### **SERVICE BULLETIN RELEASE - 08/29/2014**

<b>Subject:</b>  A/T SHIFT LEVER IS HARD TO MOVE	<b>Bulletin No:</b> 05-009/14
	<b>Last Issued:</b> 08/29/2014

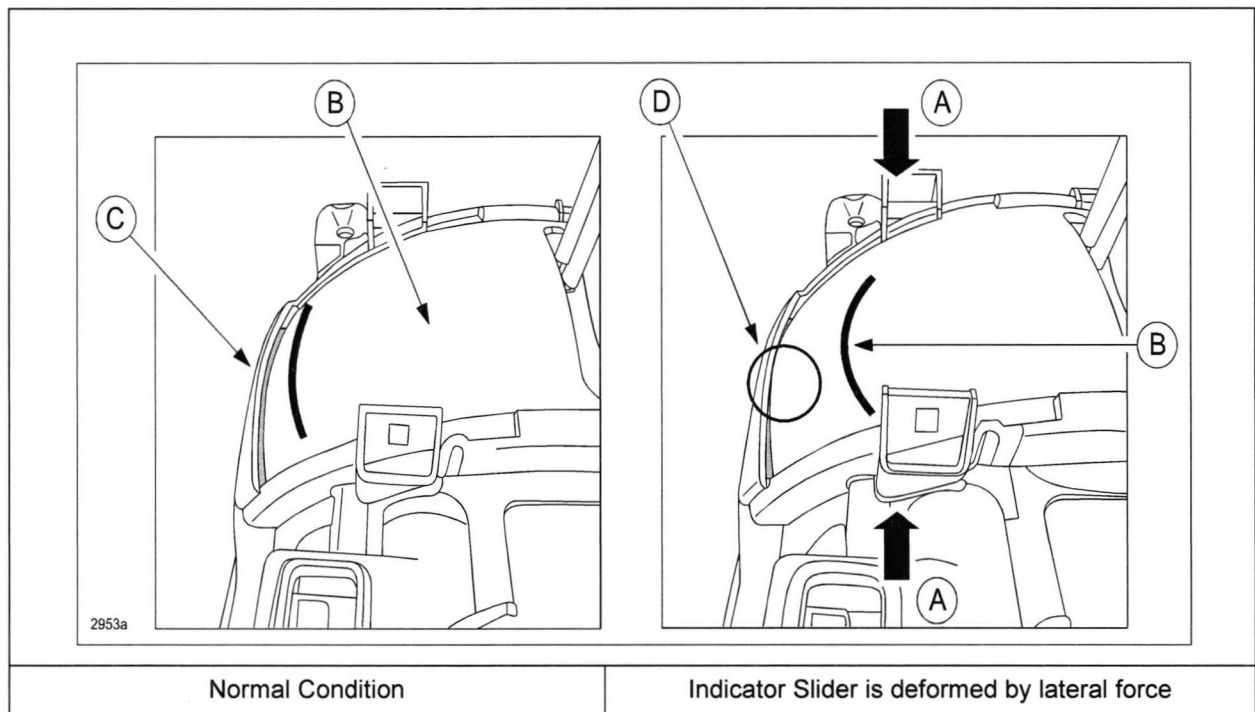
When the driver or front passenger's leg contacts the center console, lateral force (A) may deform the indicator slider (B), causing the slider edge to contact the arched part of the set plate (D). This may cause damage to the indicator slider (B) and/or hard A/T shift lever movement.

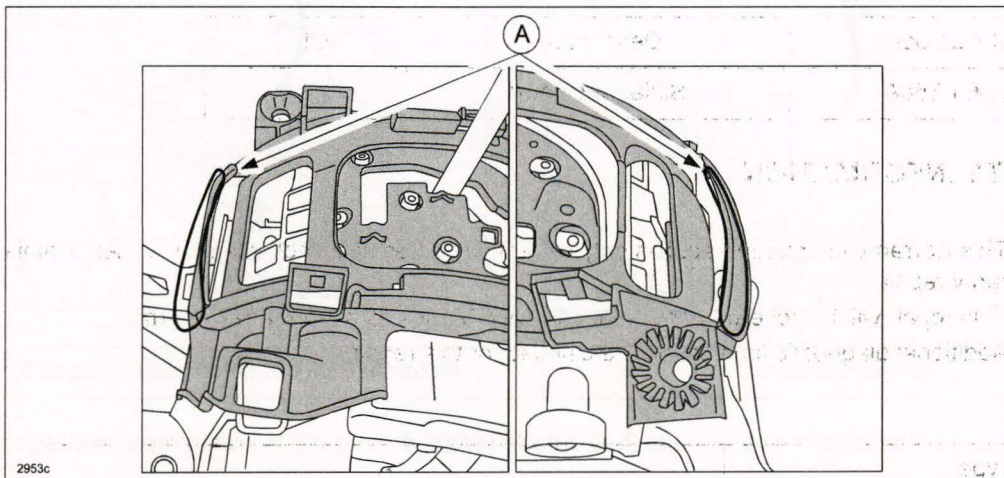
1. Verify the customer concern.
2. Remove the front console from the vehicle according to the instructions on MS3 online or the Workshop Manual (section 09-17 FRONT CONSOLE REMOVAL/INSTALLATION).
3. Remove the old indicator slider and discard it.
4. With the set plate installed in the vehicle, cut off the front and rear arched parts.
  - a. Cut the four areas indicated by circles in the figure below.

**NOTE:** The select lever unit is removed in the illustration below for viewing purpose only.

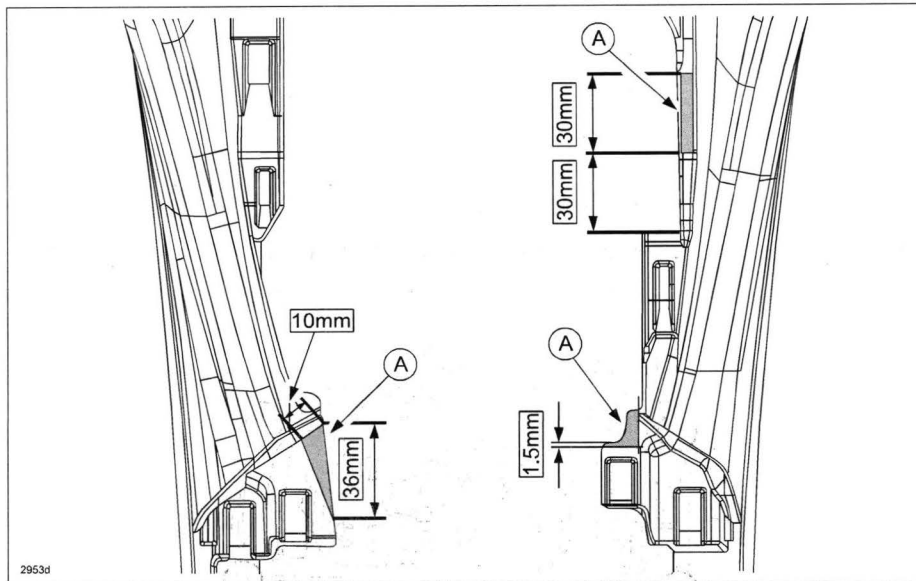
- b. Remove the front and rear arched parts (A) from the set plate.
